NEW MEXICO NATURAL HISTORY MUSEUM - GEORGIA-PACIFIC CONTROVERSY

Georgia Pacific Corporation Distribution Center in Albuquerque, New Mexico. Site Drainage and Pavement Repair Project.

DRAINAGE STUDY

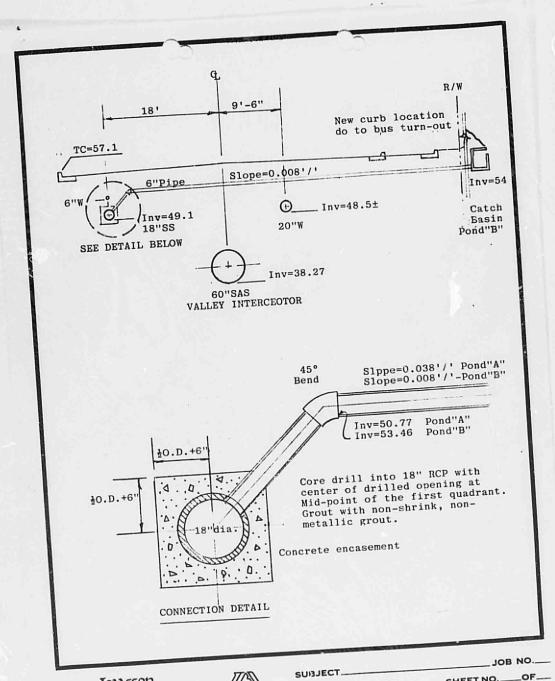
- A design for the two private drains connecting to the 18" storm sewer has been submitted to Bob Kielick on the S.O. No. 19 format. Review comments received from the Design Section were favorable for the connection. Resubmitted for approval, November 9, 1981.
- 6. See "Addition to Drainage Exhibit" sheet.

All of the minor points of clarification have been resolved and would like to go for Drainage Report Approval.
